# F6 Extension Stage 1

New M5 Motorway at Arncliffe to  
President Avenue at Kogarah

Preferred infrastructure report

Figure 2-2 Proposed changes to access at Moorefield Estate

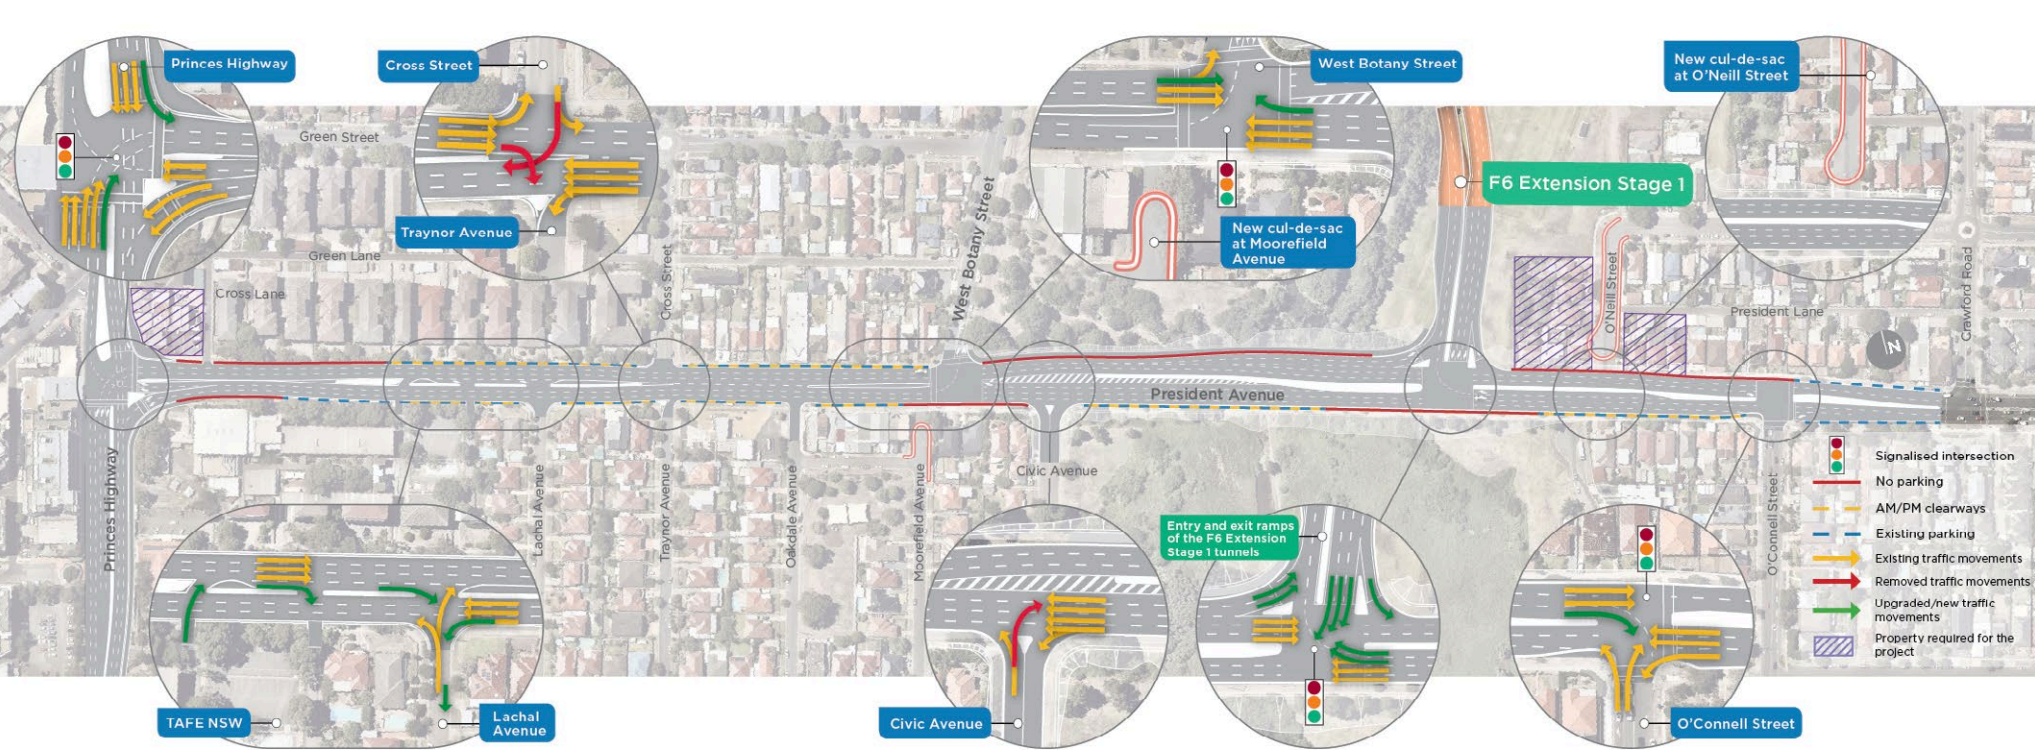
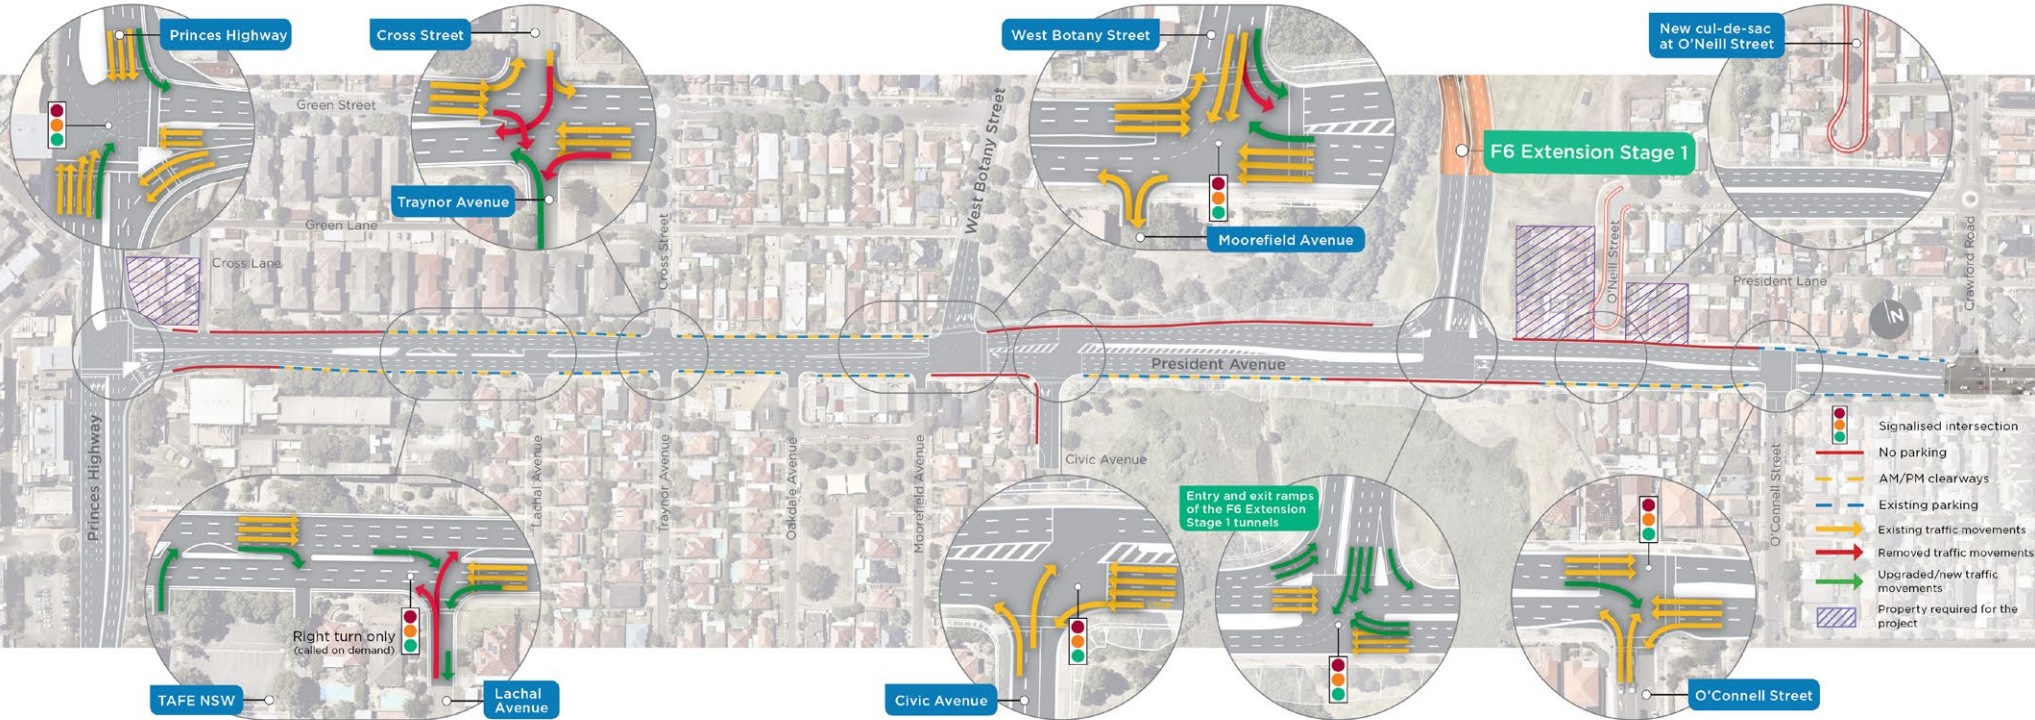
- Lachal Avenue would be converted from one-way northbound to one-way southbound (inbound movements from President Avenue only). A right turn bay and traffic signals would be provided for the right turn into Lachal Avenue from President Avenue, to ensure safe vehicle movements. A pedestrian crossing would be provided across Lachal Avenue

- Traynor Avenue would be converted from one-way southbound to one-way northbound. Only left turn movements out of President Avenue would be permitted. This change would allow Lachal Avenue and Traynor Avenue to continue to operate as a one-way pair

- The cul-de-sac at Moorefield Avenue, as described in the EIS, would not proceed. Following a review of demand, it was determined that Moorefield Avenue could remain open in its existing arrangement as a left in, left out intersection

- An additional 60 metre southbound left turn bay at the existing signalised intersection at West Botany Street and President Avenue would be provided
- A signalised intersection would be provided to allow for safer right turn movements from Civic Avenue into President Avenue. Available traffic movements would remain the same as the existing network configuration, with no right turns permitted from President Avenue into Civic Avenue. The President Avenue/Civic Avenue and the President Avenue/West Botany Street

intersections would operate under one signal controller to allow better control of traffic movements at this section of the President Avenue corridor. A pedestrian crossing would be provided across Civic Avenue.

Further detail on the proposed changes is provided in **Table 2-1**, including a comparison of the proposed changes with the existing and EIS access arrangements. The EIS access arrangements are shown in **Figure 2-1** and the proposed access arrangements are shown in **Figure 2-2**. Traffic modelling has confirmed that the proposed access arrangements are satisfactory from a road network perspective, as described further in **section 2.4**.

Road (at intersection with President Avenue)	Existing arrangement	EIS arrangement	Proposed arrangement	Justification for change
Lachal Avenue	One-way northbound (outbound movements to President Avenue only).	Lachal Avenue would be converted from one-way northbound to two-way. A right turn bay would be provided to formalise the right turn into Lachal Avenue from President Avenue, and to ensure safe vehicle movements. A refuge bay would be provided for the right turn out of Lachal Avenue onto President Avenue to ensure safe vehicle movements.	Lachal Avenue would be converted from one-way northbound to one-way southbound (inbound movements from President Avenue only). A right turn bay and traffic signals would be provided for the right turn into Lachal Avenue from President Avenue, to ensure safe vehicle movements. A pedestrian crossing would be provided across Lachal Avenue. The proposed arrangement means that on-street parking restrictions would not be required on Lachal Avenue, which would remain as a one-way street.	Provides a signalised right turn movement into the Moorefield Estate area, thereby reducing potential traffic conflicts. Maintaining one-way operation reduces impacts on Lachal Avenue.

Traynor Avenue	One-way southbound (inbound movements from President Avenue only). Left and right turn from President Avenue permitted.	Traynor Avenue would be retained as one-way southbound. Due to the right turn arrangements at Lachal Avenue, the right turn into Traynor Avenue would not be possible, but the left in movement would remain.	Traynor Avenue would be converted from one-way southbound to one-way northbound. Left turn out onto President Avenue only.	Allows Traynor Avenue and Lachal Avenue to operate as a one-way pair, with a right turn in movement allowed at Lachal Avenue. Safe right turn movements onto President Avenue can be made via the proposed signalised Civic Avenue intersection arrangement described below.
Oakdale Avenue	Two-way. All movements allowed.	No change to existing traffic movements.	No change to existing.	No change to existing.
Moorefield Avenue	Two-way. Left in and left out only.	Moorefield Avenue would be converted to a cul-de-sac at President Avenue to relocate movements to a safer location for vehicles as they turn in or out of the upgraded President Avenue.	No change to existing. Two-way. Left in and left out only.	Based on the surveyed and forecast traffic volumes using this intersection, it was determined that it could remain open and not require a cul-de-sac.

West Botany Street	Signalised intersection.	No change to existing traffic movements.	Provision of an additional 60 metre southbound left turn bay at the existing signalised intersection	Reduces the forecast queue length on the West Botany Street approach.

**Figure 3-1** Alignment of the proposed shared cycle and pedestrian pathways for the project

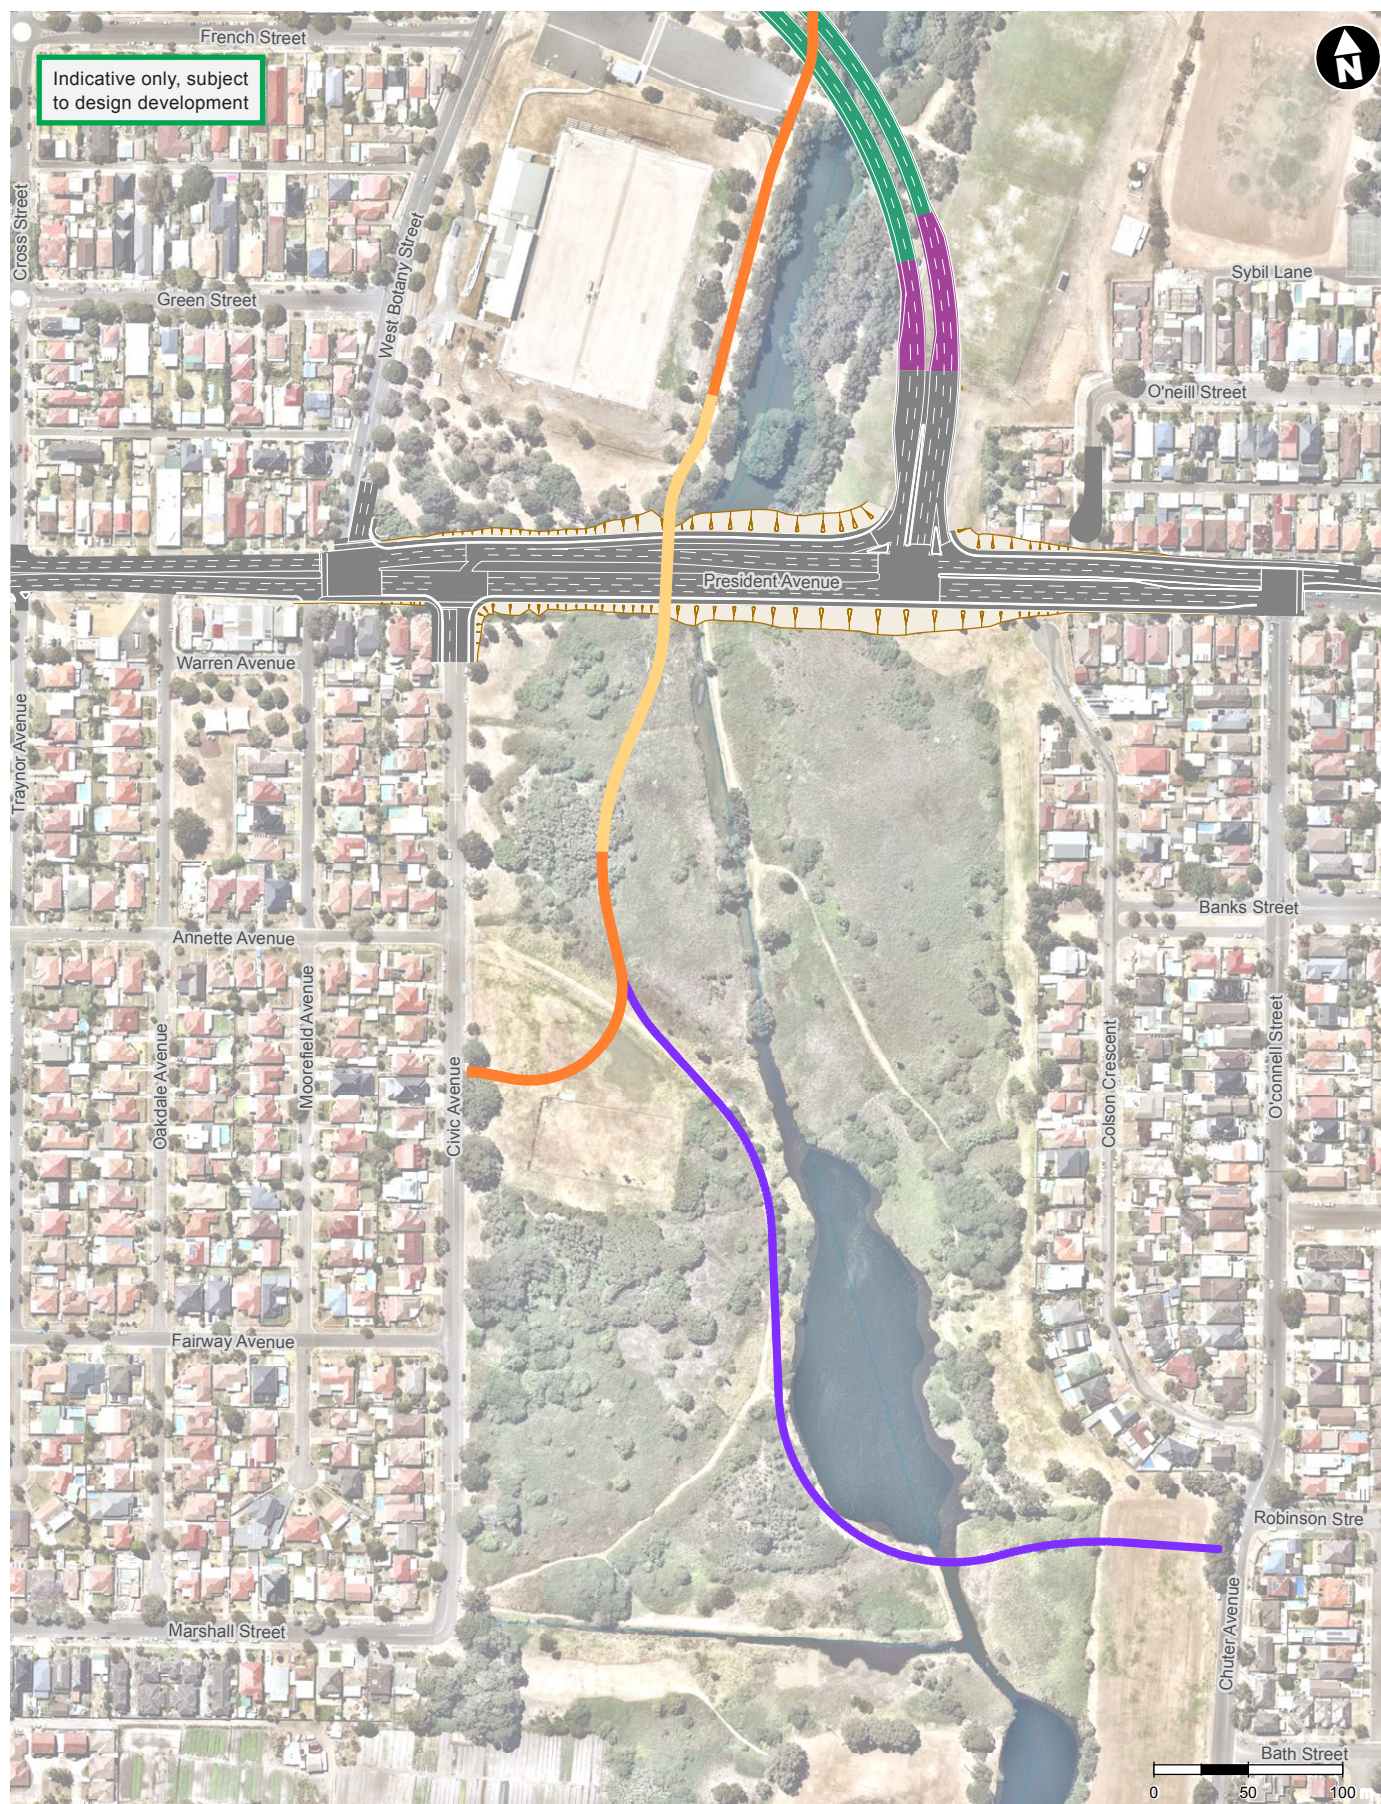
The shared cycle and pedestrian pathways proposed in section 6.8 of the EIS would be extended from President Avenue through Scarborough Park North across to Chuter Avenue/O'Connell Street. The proposed extension would:

- Increase the shared cycle and pedestrian pathway proposed in the EIS by around 600 metres south from the connection to Civic Avenue
- Be constructed as a 3 metre wide boardwalk (or other low impact design) to minimise potential flooding impacts and would generally follow existing informal walking/access tracks within Scarborough Park
- Cross the watercourse in Scarborough Park via a steel bridge structure
- Include an upgraded pedestrian refuge at the connection point with the existing on road cycle network at Chuter Avenue/O'Connell Street, south of Robinson Street.

The section of the shared cycle and pedestrian pathway which links the pathway to the west towards Annette Avenue, would be retained. The proposed alignment and the original alignment presented in the EIS are shown in **Figure 3-1**.
